SERVICE KIT NO. SK-120-1A
 Supersedes SK-120-1

TITLE: CARBURETOR AIRBOX IMPROVEMENTS

SERIALS AFFECTED: AA5-0001 through AA5-0070

Figure 1. Replacement Bearing Installation

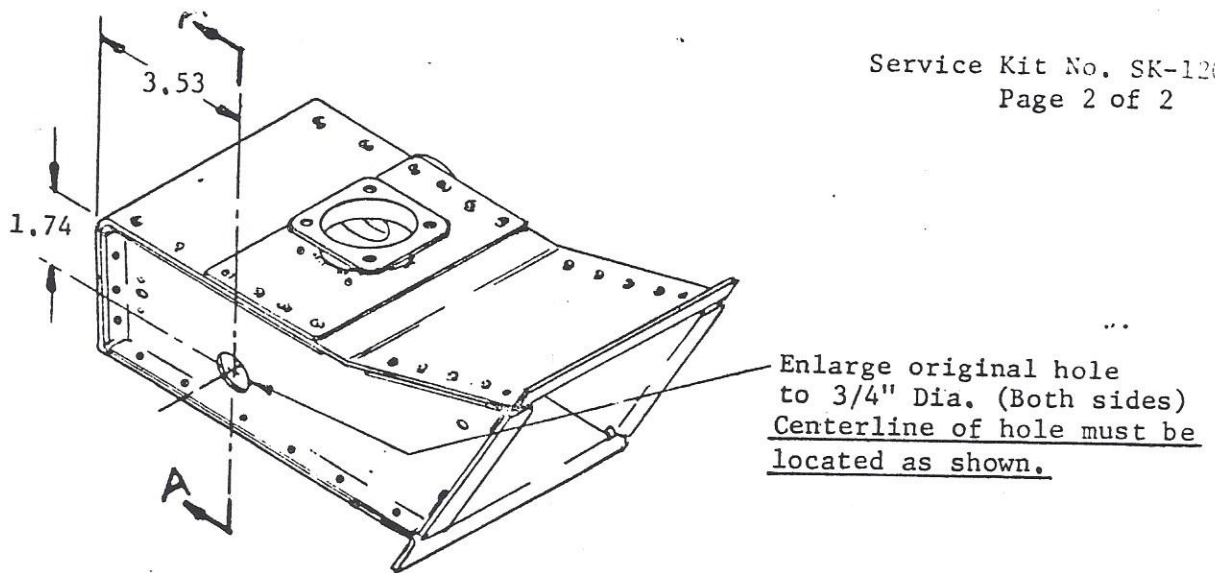
4. Enlarge the original bearing mounting holes in the sides of the airbox to 3/4" diameter. BE SURE HOLE CENTERLINES ARE LOCATED AS SHOWN IN FIGURE 1 TO ASSURE PROPER VALVE PLATE OPERATION.

Figure 3. Section AA - Modified Airbox with SK-120-1A installed.

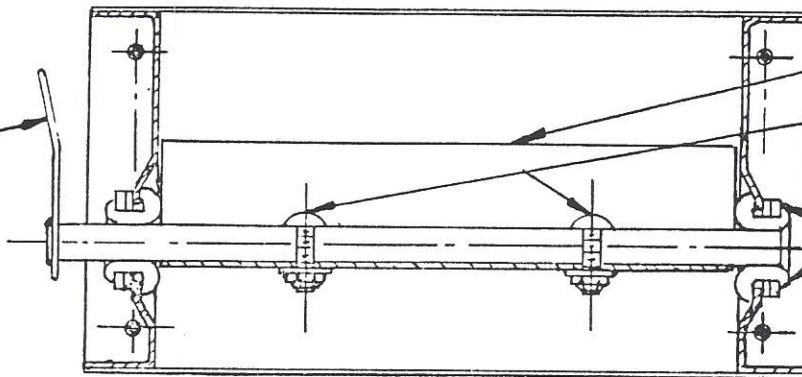
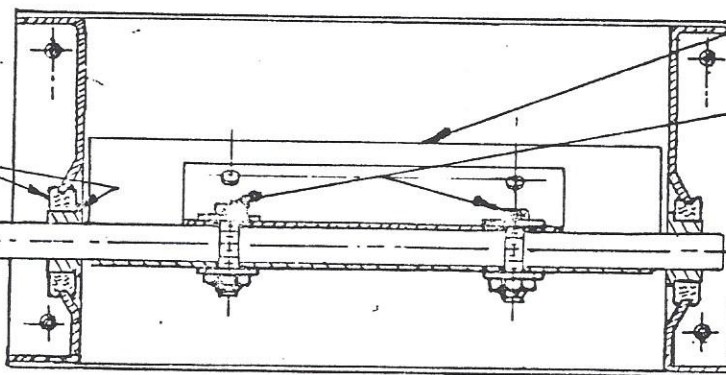
5503001-502
Shaft Assembly
with .040 thick
arm. (Discard)

5503001-9 Valve
(Discard)

Discard original
screws, washers
and nuts.

Discard original
bearings and
washers.

Figure 2. Section AA - Original Airbox Design with valve and bearings installed.
(AA5-0001 thru AA5-0070)

5. Insert the MS35489-7 grommets (2) and 4L4-F nyliners (2) in the airbox as shown in Figure 3. Install the 4L4-F nyliners with the shoulder on the inside.

5503001-502
Shaft Assembly
with .080 thick
arm.

Insert MS35489-7
grommet and 4L4-F
nyliner on each
side of airbox.
Install nyliner
with flange inside.

5503001-504
Valve Assembly

MS35457-9 screw (2)
MS20365-632C nut (2)
AN960-6 washer (4)

Figure 4. Control Arm Swivel Assembly

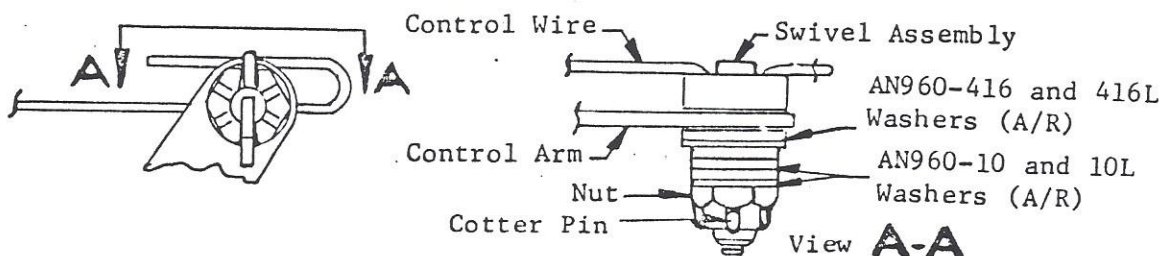
8. Reinstall airbox on aircraft. Replace valve control arm swivel fitting with new fitting supplied in Kit, shimming as required with washers supplied in Kit. (See Figure 4). Check swivel fitting for freedom of movement on arm.
